SUBJECT: Corrective Measures Implementation/Remedial Action Implementation Plan for the Wetland Area at Dunbarton Bay in Support of Steel Creek Integrator Operable Unit (U) (SRNS-RP-2018-00481, Redline Revision 1, November 2018), Land Use Control Implementation Plan for the Wetland Area at Dunbarton Bay in Support of Steel Creek Integrator Operable Unit (U) (SRNS-RP-2018-00479, Redline Revision 1, November 2018), Field Sampling Plan for the Wetland Area at Dunbarton Bay in Support of Steel Creek Integrator Operable Unit (U) (SRNS-RP-2018-00480, Redline Revision 1, November 2018), and Savannah River Site's Responses to the Regulatory Comments on the Revision 0 Documents, SEMS Number: 71

**SRS Responses to South Carolina Department of Health and Environmental
Control Comments on the Corrective Measures Implementation/Remedial Action
Implementation Plan for the Wetland Area at Dunbarton Bay in Support of Steel
Creek Integrator Operable Unit (U), SRNS-RP-2018-00481, Revision 0, June 2018,
SEMS Number 71, received June 6, 2018.
Comments Received 08/30/2018**

**SRS Responses to EPA Comments on the
Corrective Measures Implementation/Remedial Action Implementation Plan for the
Wetland Ar

Figure 4. Land Use Control Boundary for the WADB (Revised)

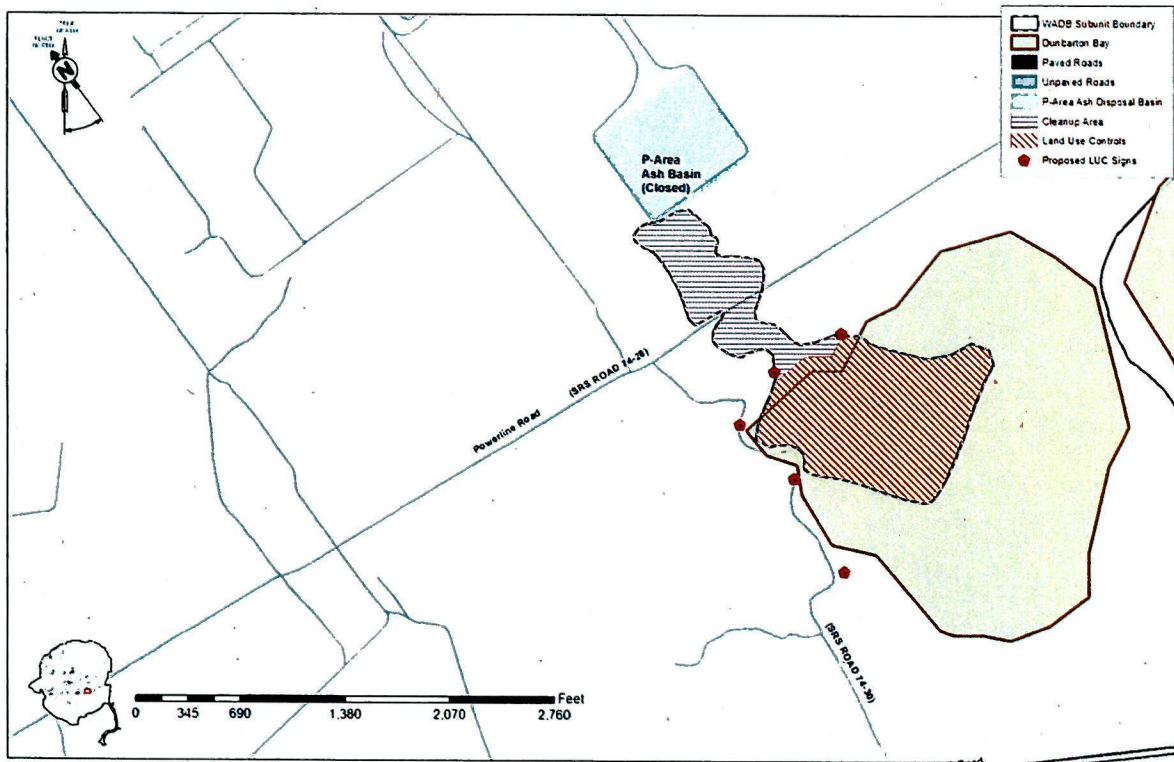
It is unclear which compass direction the warning signs face, as this is not specified. If signs are to face away from Dunbarton Bay, it is unclear if a trespasser potentially could access the site from Dunbarton Bay itself, especially during the dry season. Similarly, it is unclear why four signs are sufficient. For example, it is unclear if additional signs along the road to the southwest of Dunbarton Bay are warranted. *Revise Section 4.5 to clarify the compass direction the warning signs will face, and provide rationale for the selected direction. In addition, provide rationale for the number of signs to be installed.*

The ash that will remain in place and subject to LUCs is within the buffer area and the northwest portion of Dunbarton Bay. The most likely access points to this area of Dunbarton Bay are from one of two secondary roads identified as the Powerline Road (74-28) or an unpaved secondary road that intersects Road B, south of Dunbarton Bay (74-30). The figure showing the location of these access signs will be modified to show the secondary roads and the intersection of these roads with the primary roads, Road B and Road F. An additional sign will be added to warn a trespasser encroaching from the secondary road that intersects Road B. The revised figure is attached to these comment responses.

“Five proposed locations have been selected for the access control warning signs as shown in Figure 4. These locations range between 150 and 200 ft apart from each other and are positioned at likely ingress points. Access to this area is from either of two secondary roads, the Powerline Road (SRS road 74-28) or an unpaved secondary road that intersects Road B (SRS Road 74-30). Signs parallel to the Powerline Road ingress points will be oriented to the north, and signs along SRS Road 74-30 will be oriented to the west. —In addition, the, The

Figure 4. WADB Sampling Grid Locations (Revised to add sample location N-07)

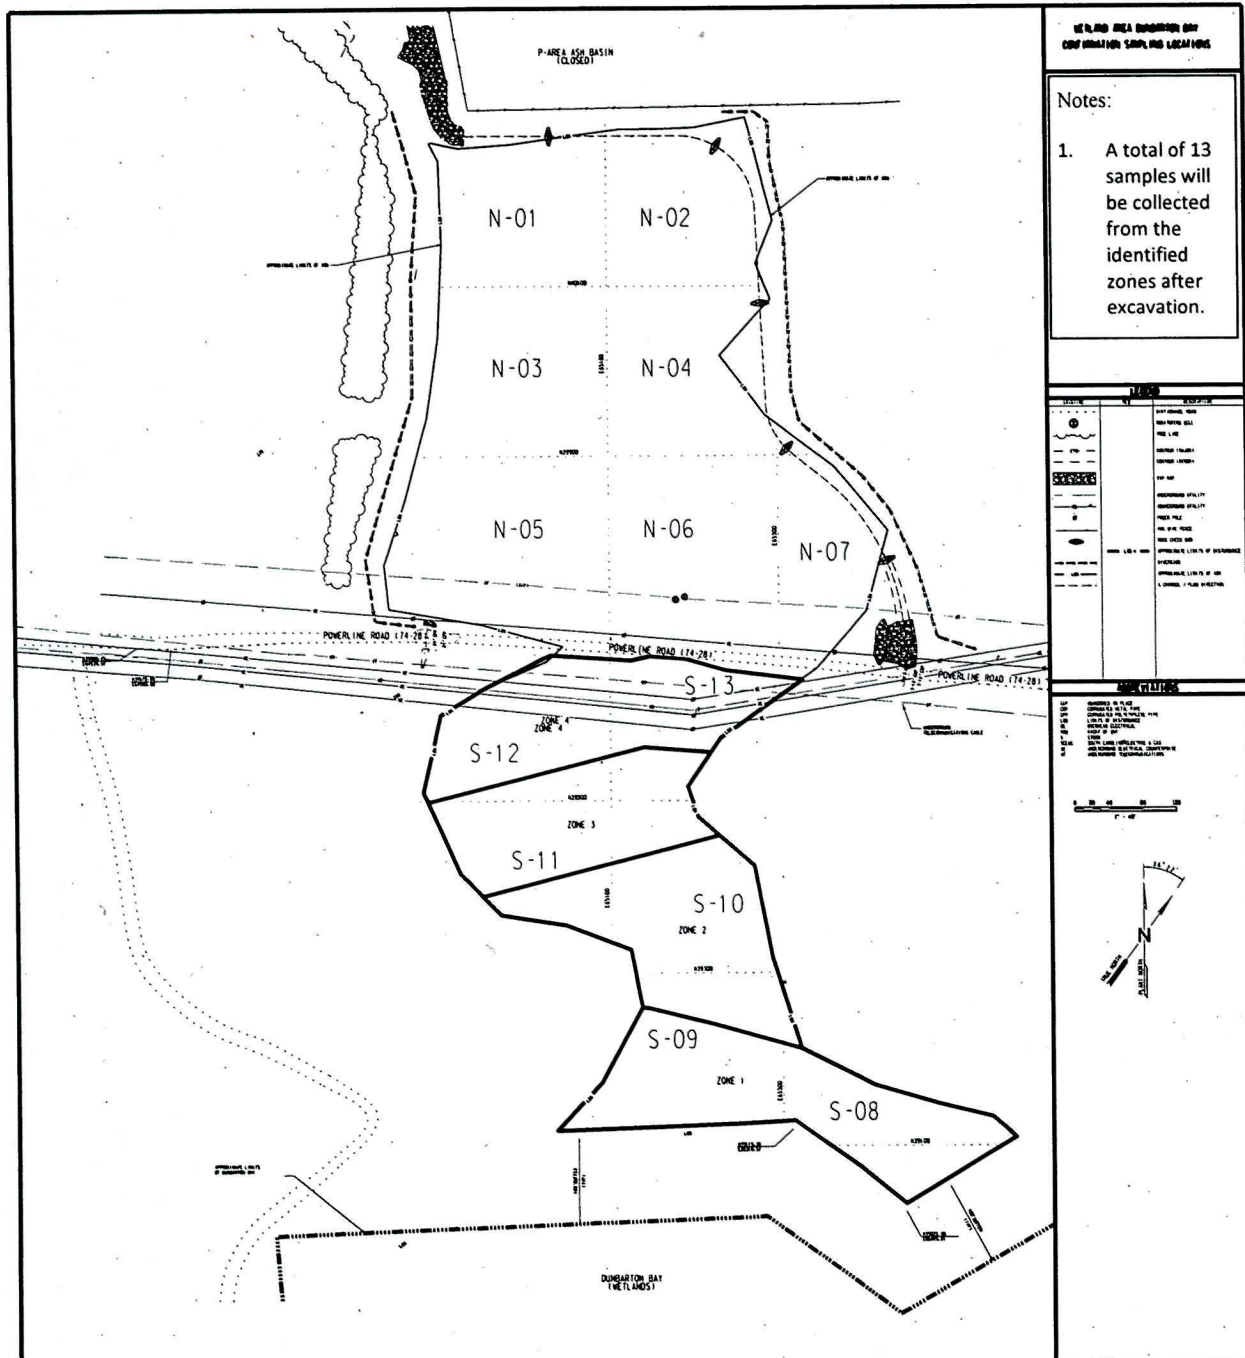
Review of this figure indicates that a large area of excavation is proposed to the east of grid square N-06; however, no confirmation sample is proposed in this area. To ensure that contamination is sufficiently removed from this area, it appears that collection of an additional confirmation sample in this area is warranted. Revise the FSP to propose the collection of an additional confirmation sample from the grid square located east of grid square N-06, or justify why this is not necessary.

An additional sampling location has been added to account for geometry of the extent of ash. Ash was deposited in the remediation area due to overflow from the now closed P-Ash Basin. The ash followed the natural drainage pattern and topography. The overflow area is unlike a typical basin in that there are no areas designated as a “floor” or “sidewall”. The number of samples is distributed over the sampling grid is slightly greater than the general rule of one sample per acre as prescribed in *Confirmation Sampling and Analysis Plan for Coal and/or Ash Removal at the Savannah River Site (U)*. The rationale for the selected confirmation frequency has been added to Section 2.0, Analytical Plan, as identified below:

An additional sampling location has been added to account for geometry of the extent of ash. Please see the response to comment 4 and the revised sampling grid attached to these responses.
